# Tu15a

Subject: **Addendum to A-3-MRA-14-0050 and 9-14-1735 – California  
American Water Company Test Well**

This addendum provides proposed revisions to the staff report, correspondence received, and *ex parte* submittals. These revisions do not change staff's recommendation that the Commission conditionally **approve** the coastal development permits.

**Figure 5 – Monitoring Well MW-1S Drawdown Data**

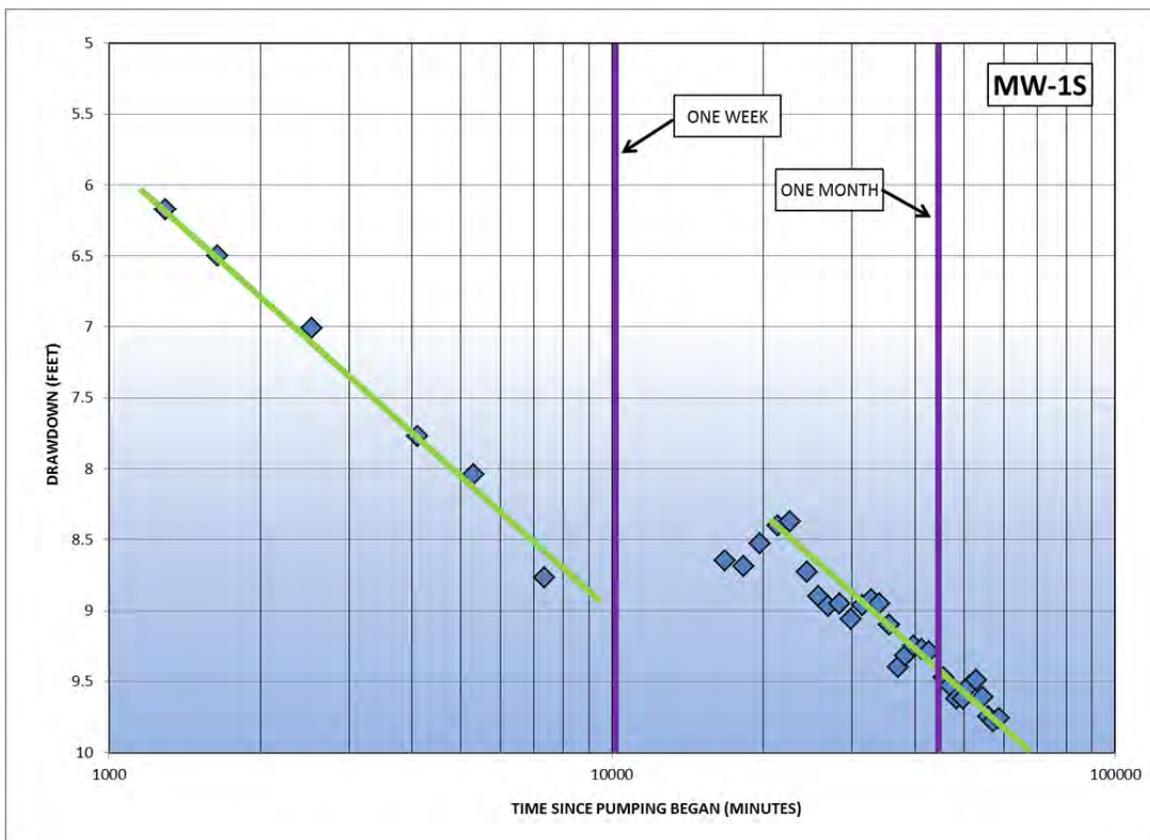
In addition, the component of groundwater produced will likely be significantly greater than the model predicted. The hand-measurement water level data from the MW-1S and MW-3S monitoring well installations are provided in Figures 5 and 6 – Monitoring Well MW-1S and MW-3S Drawdown Data, respectively, show a downward trend in the water levels that continued until pumping terminated in June and does not indicate stabilization associated with a boundary condition from a source of recharge. As result, it is highly likely that drawdown from the TSW’s production will continue and extend further if operations resume.

**Figure 11 – Particle Tracking With 8-Foot Background Gradient**

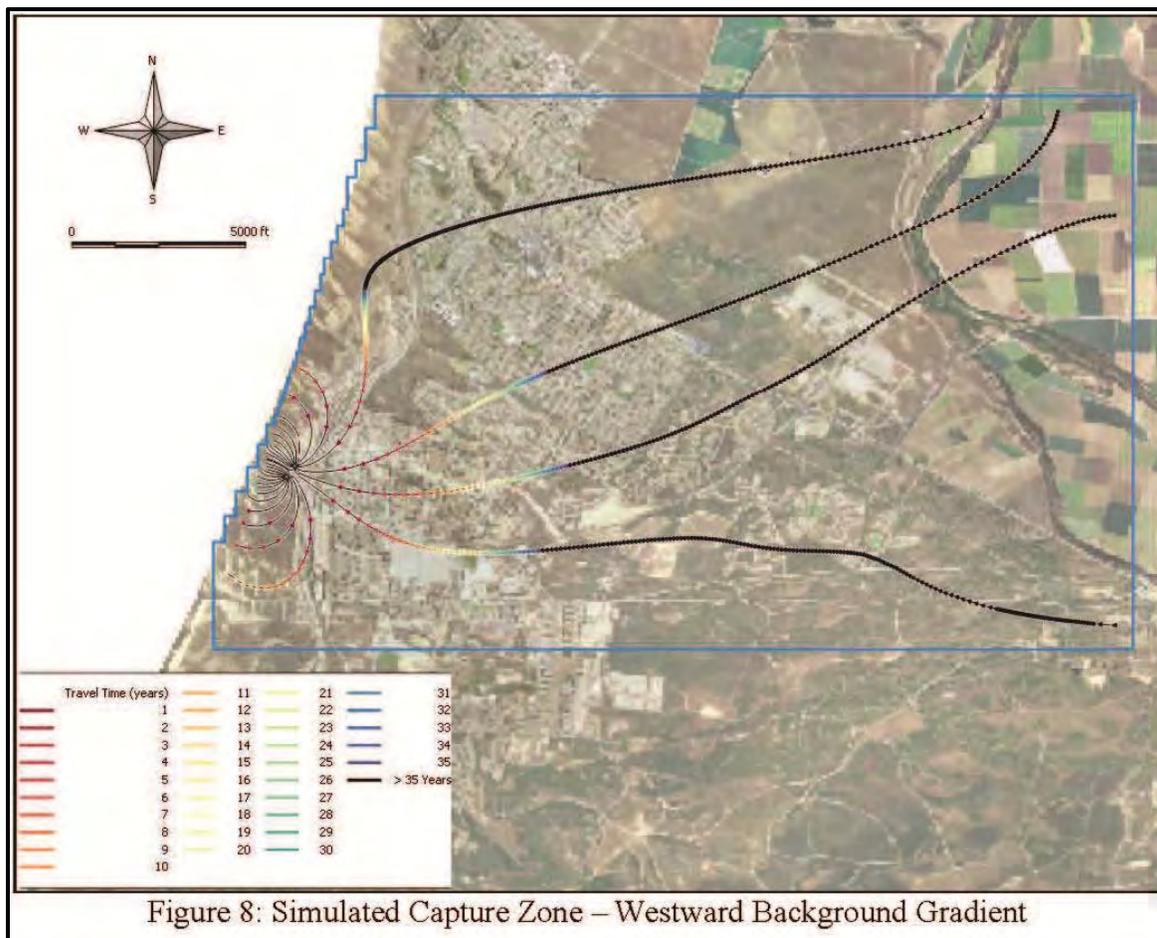
Third, the TSW will likely have impacts beyond the cone of depression originally estimated by Cal-Am as discussed above. If the TSW production results in drawdown at an extended distance from the well, the increase to the existing gradient that exists in the 180-Foot Aquifer would accelerate landward movement of seawater. The movement of seawater into the aquifer at greater distances beyond the zone of capture of the test slant well, will continue to move with the prevailing gradient, which is generally inland within the 180-Foot Aquifer except as indicated above by Monitoring Well MW-7M. As discussed below, MW-4 would be unlikely to detect this change during the duration of TSW pumping. The steep gradient flowing toward the shoreline in the shallow perched Dune Sand Aquifer along with the proportional shift of production from the 180-Foot Aquifer (71 percent simulated by the MPWSP model) to the Dune Sand Aquifer (80 percent reported from the TSW) indicate that the Cal-Am's model calculations of groundwater production (4 to 7 percent) is inaccurate and may underestimate the groundwater capture by 3 times the amount.

**Figure 12 – MW-4S Data Set**

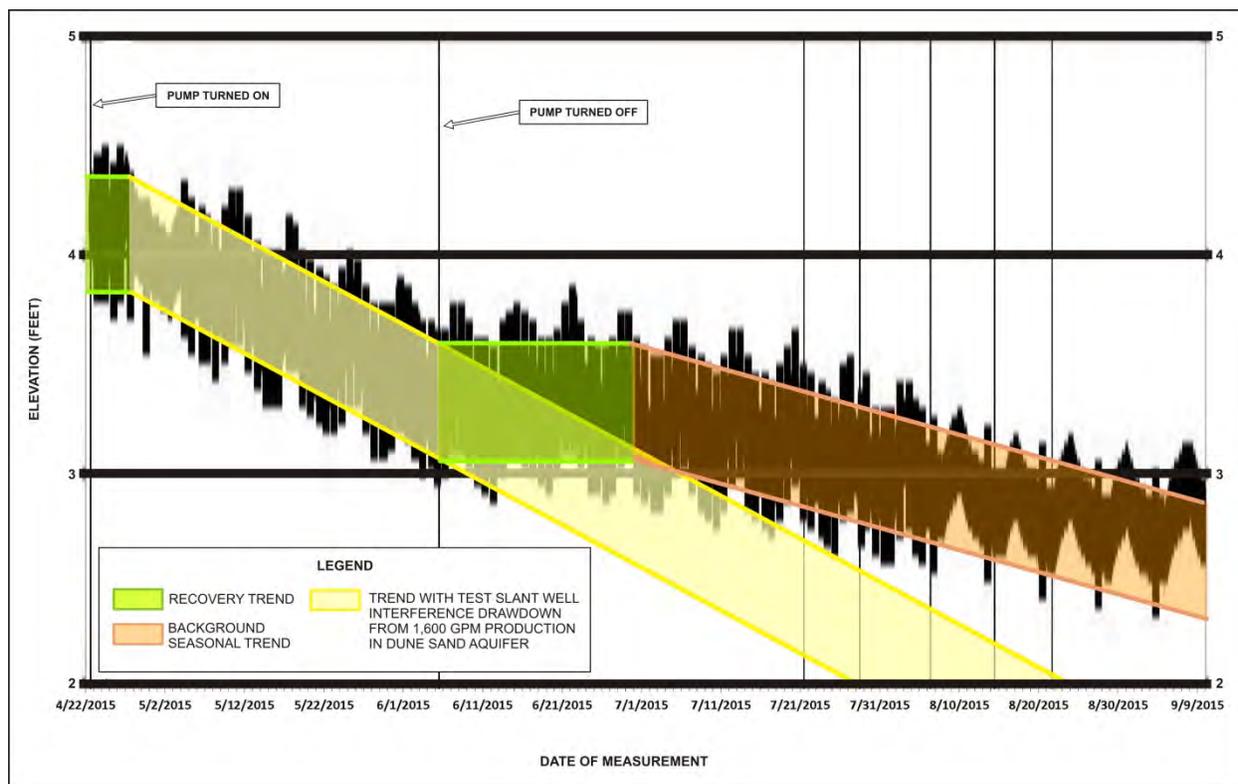
Cal-Am now. Again, a 1.5-foot decline in water levels when basin levels are 10-feet above sea level may have an insignificant impact compared to a 1.5-foot decline when water levels are at or below sea level. Unless, the CCC evaluates the performance standard based on potential seasonal levels decline in the Marina subarea under the potential further extended drought conditions the change is clearly inappropriate.

Moreover, as noted above, establishing trends is not an exact science and could be the subject of significant scientific disagreement. The HWG states that “precise calculations of drawdown in MW-4S and 4M are somewhat difficult, given that the drawdowns are very small to negligible and superimposed on a declining regional water level trend.” In the Geoscience reports, the vertical axis scale for Monitoring Well MW-4 spans from -20 feet to 45 feet above mean sea level (65 feet). The result is that the data appear to form a straight line, which is what the HWG concludes. When the scale is changed to be appropriate for the data set (3 feet total), trends become more visible. Figure 12 – MW-4S Data Set is an enlargement of a graph provided in Figure 2-3 of the Test Slant Well Long Term Pumping Test Report No. 20, which was necessary because these data are not provided otherwise. Evaluation of the data from MW-4S clearly shows a steeper gradient during the TSW pumping period, followed by a slightly increasing or flat recovery period trend in water levels. This clearly shows that the response is from the TSW pumping. If the well had continued to operate, the projected water levels shown in yellow would be substantially lower than the decline related to the background seasonal trend shown in orange.

**Figure 13 – Five-Day Test, Test Slant Well Data**

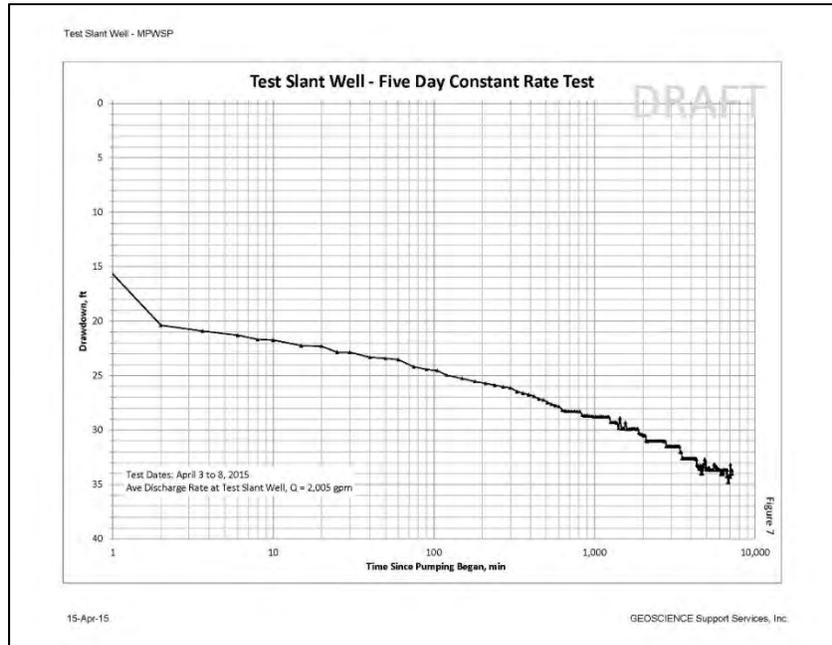
A boundary condition restricting flow was indicated in both the 5-day and the long-term test data after approximately 1 day of pumping. At that time, the rate of drawdown increased

**Figure 14 – Five Day Test, Monitoring Well MW-1 Data**

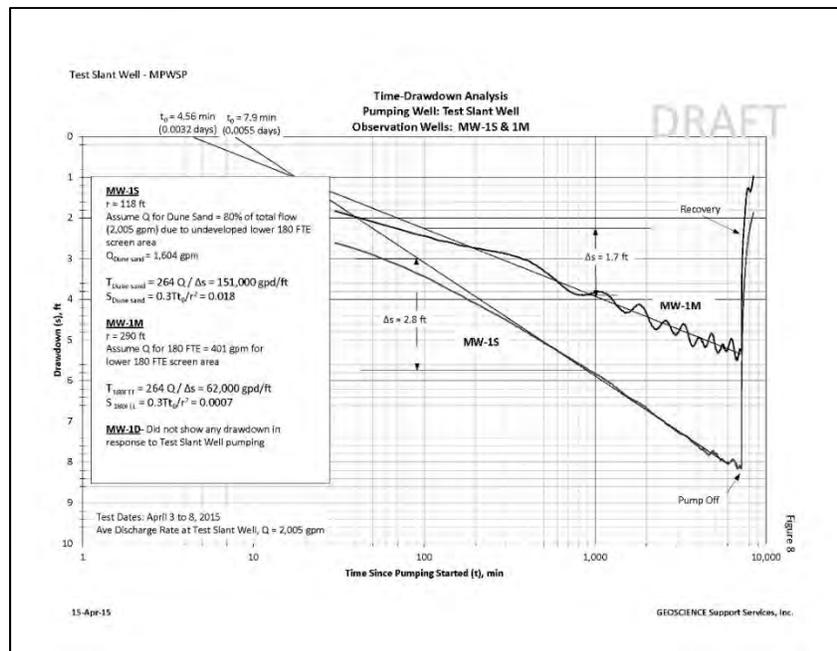
and continued throughout the first week. At approximately one week of pumping, the data appear to show an increase in well performance, which caused the pumping water level in the well to rise or flatten out. The subsequent declining water level trend over the next 2 weeks is consistent with the trend observed between days 2 through 5. It is unclear if the subsequent water level rise is due to further improvement in well performance or a reduction in pumping rate. However, the last couple weeks indicate a relatively stable water level which may indicate the recharge boundary of the ocean was achieved. Again as shown in Figures 5 and 6, this recharge boundary was not visible in late time data in Monitoring Well MW-1 and MW-3.

**Figure 15 – Long-Term Test, Test Slant Well Data**

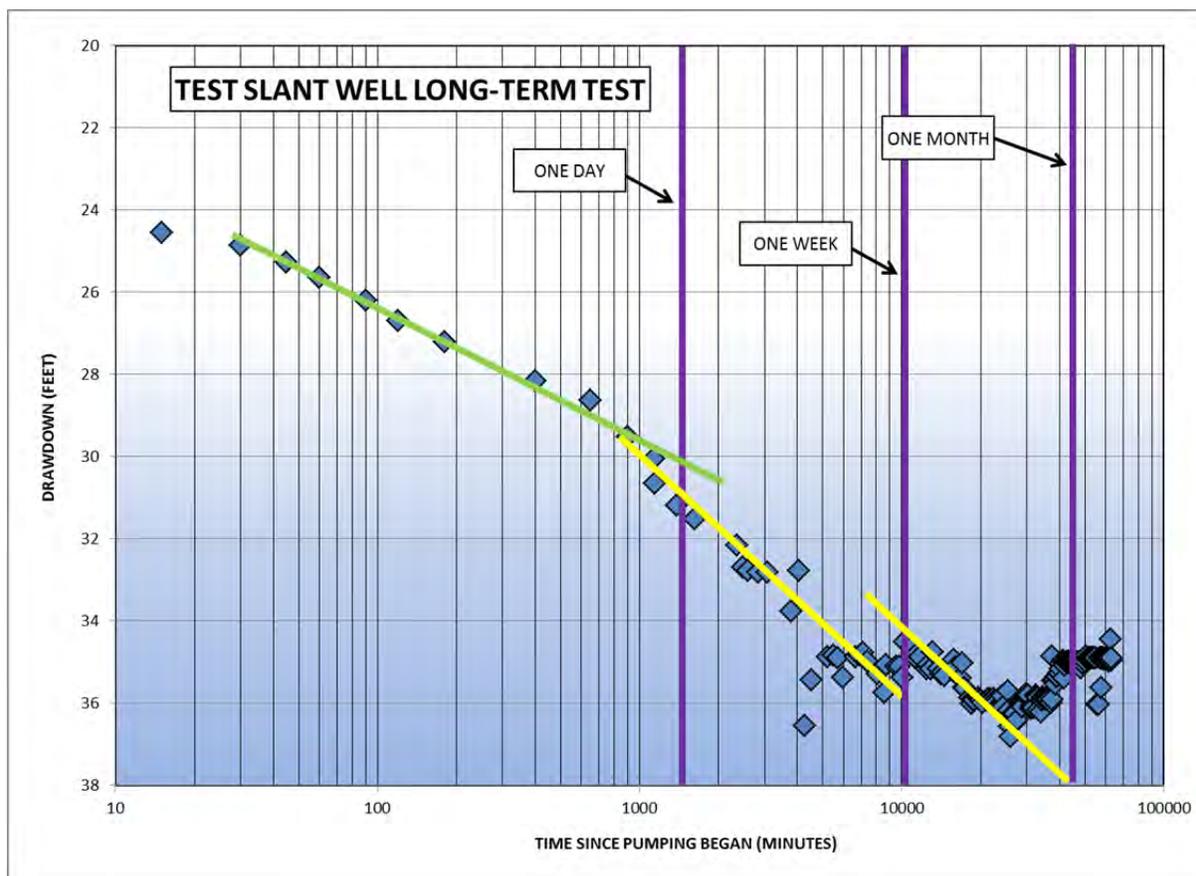
Review of the long-term test hand water level measurement data shown in Figure 15 – Long-Term Test, Test Slant Well Data, that were provided upon request, also indicates that a constant rate of drawdown in the TSW occurs well beyond a week after pumping started. After a week of pumping, the data appear to show a water level stabilization. However, subsequent data show the same downward trend for another couple weeks. The data then show a rise in level and a stabilized drawdown through the remainder of the test period. Factors contributing to changes in water level drawdown rates include; continued development of the well screen intervals, fluctuation in well production rates, and aquifer boundary conditions.

Despite these variables, the HWG suggests that any drawdown at MW-4 should be attributed to regional trends. In support of their opinion, they cite data of seasonal declines in the 180-Foot Aquifer throughout the Salinas Valley Groundwater Basin. With the exception of the monitoring well data, however, all the rest of the well data provided by the HWG is from outside the Marina Subarea (North of the Salina River, see HWG Letter Exhibit entitled “180 Aquifer Well Hydrographs Monterey Peninsula Water Supply Project”), is from 2012 or 2013, and is miles from the Coast. Thus, these data do not address the seasonal trends in the Project area during the TSW pumping period. It is well known that the 180-Foot Aquifer and 400-Foot Aquifer are subject to extensive seasonal variation. In fact as we have noted in the MCWD v. CCC litigation average water level in the Pressure 180-foot Aquifer rose 10-feet from August 2013 to February 2014, and then declined 20-feet from February 2014 to July 2014. (Monterey County Water Resources Agency’s Salinas Valley Water Conditions for the Fourth Quarter of Water Year 2013-2014.) But as HWG Martin Feeney testified in that case, “it would be hydraulically impossible for water levels to fluctuate to this degree at the Project location.” (Declaration of Martin Feeney in Support of Cal-Am’s Opposition to Motion For Stay And Preliminary Injunction, p. 11.) This is especially true given the unique hydrogeology of the Marina subarea and recharge provided by the Dune Sand Aquifer. Thus, while the 2012 and 2013 well data from outside the Marina subarea supports the unremarkable proposition there are large seasonal groundwater trends in the SVGB, it cannot be used to calculate daily average trends within the Marina subarea for 2015. As discussed above, the unique conditions in the Marina Subarea (perched Dune Sand Aquifer and lack of pumping) show that unlike other areas in the SVGB, conditions are getting better.
